**Sun Energy Group, LLC's
“Louisiana Gasification Facility”
Plasma Arc Garbage Incinerator in Disguise
Proposed for New Orleans**

**Greenaction for Health and Environmental Justice
June 16, 2011**

The diagram below, also from Westinghouse Plasma's website, is of the Hitachi Metals plasma arc plant in Utashinai, Japan and clearly shows a large stack.⁵²

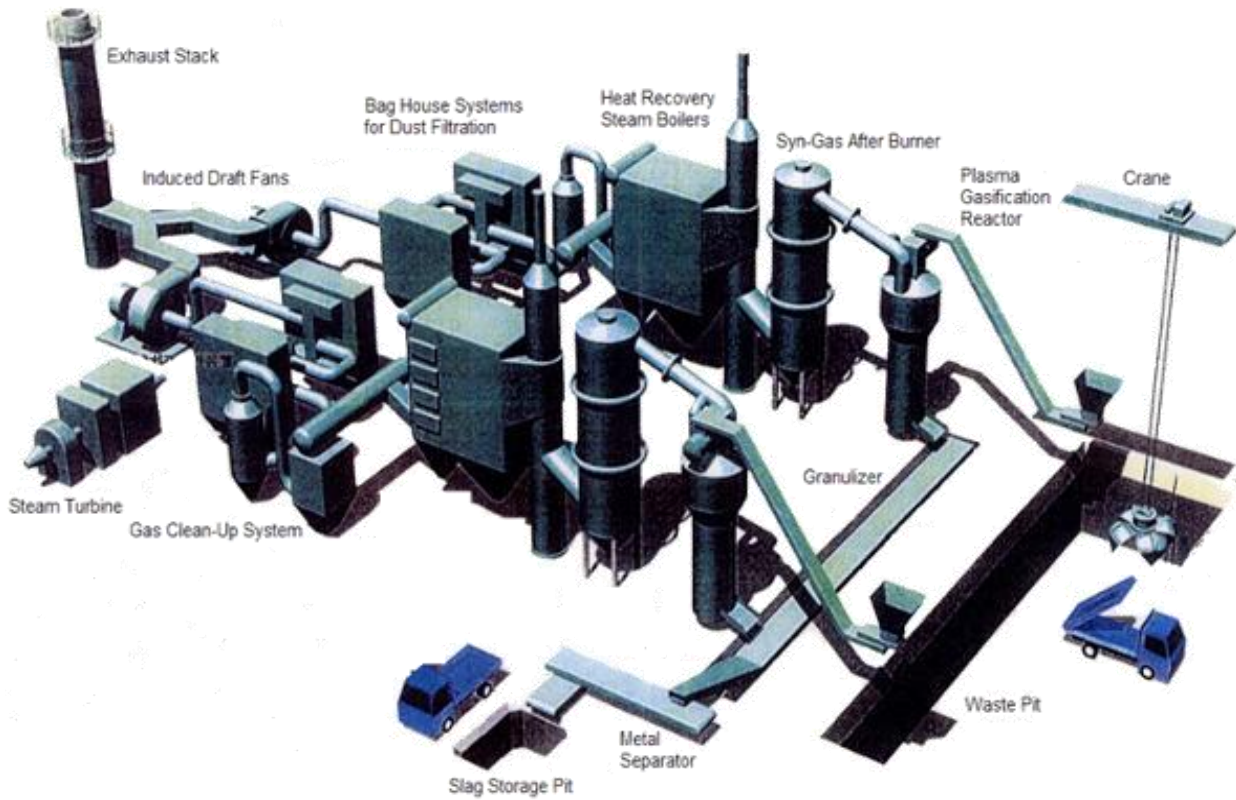
Whether intentional or negligent, the diagram above provided by Westinghouse Plasma omits the combustion equipment (a boiler or turbine) and omits any picture or mention of the stack that will emit the pollutants after the syngas is burned. This omission is very serious as the diagram gives the impression there is no stack when in fact there would be a stack.

The photo of the Hitachi Metals plasma arc plant in Utashinai, Japan curiously omits the stack associated with the facility, and toxic pollutants are emitted from that stack.

Despite the photo of part of the Utashinai facility that does not show any stack, Sacramento City official Jim Rinehart confirmed upon his return from a tour of the plant that there is a stack.⁵¹

On the inside of this same Hitachi Metals publication is a photo, below, of a similar (or the same) Japanese facility that clearly shows a very large stack.
